Access Compliance Report

Public Rights-of-Way

Intersection ID: 53504	Main Street: CRIPPLE_CREEK_LN	Cross Street: ALLISON_LN	Location: NE
ADA ID: E725FA10051D	Ramp Type: Perp	Initial Pass/Fail: Fail	Overall Compliance: No
Severity Score: 13.75			
Codes/Mitigation Info/Possible Solution		Field Measurements/Component Compliance

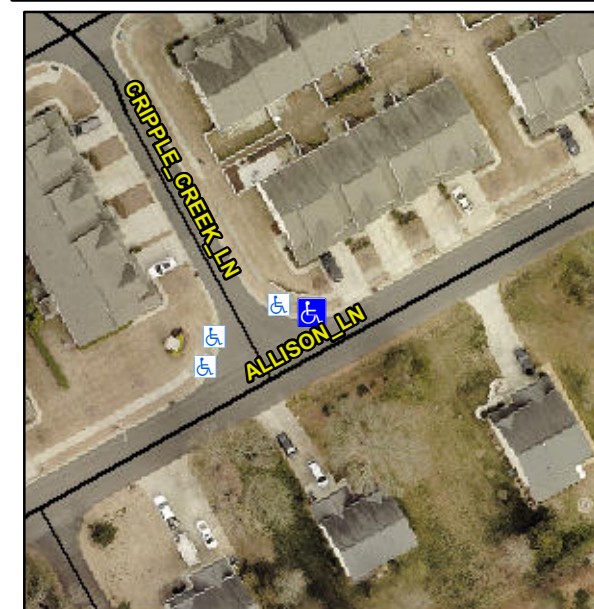
R304.2.2

Compliance	Description	Data	Compliance	Description	Data
N/A	Ramp Length (in)	63.0	No	Ramp Slope (%)	9.7
Yes	Ramp Width (in)	48.0	Yes	Ramp XSlope (%)	4.5
N/A	Flare Type LT	N/A	N/A	Flare Type RT	N/A
N/A	Flare Slope LT (%)	N/A	N/A	Flare Slope RT (%)	N/A
N/A	Flare Traversable LT?	N/A	N/A	Flare Traversable RT?	N/A
N/A	Landing Length (in)	N/A	N/A	DWS Provided?	N/A
N/A	Landing Width (in)	N/A	N/A	DWS Contrast?	N/A
N/A	Landing Slope (%)	N/A	N/A	DWS Length (in)	N/A
N/A	Landing X Slope (%)	N/A	N/A	DWS Full Width?	N/A
N/A	Landing Curb? (Y/N)	N/A	N/A	DWS Offset (in)	N/A
N/A	Shared Landing?	N/A			
N/A	Gutter Ponding?	N/A	N/A	Gutter Slope (%)	N/A
N/A	Gutter Lip Ht (in)	N/A	N/A	Gutter X Slope (%)	N/A
N/A	Painted X Walk1?	No	N/A	Painted X Walk2?	N/A
	X Walk 1 Direction	To SE		X Walk 2 Direction	N/A
N/A	X Walk 1 Width (in)	N/A	N/A	X Walk 2 Width (in)	N/A
	X Walk 1 Slope (%)	1.3		X Walk 2 Slope (%)	N/A
	X Walk 1 X Slope (%)	6.9		X Walk 2 X Slope (%)	N/A

Remove & Replace Entire Ramp.
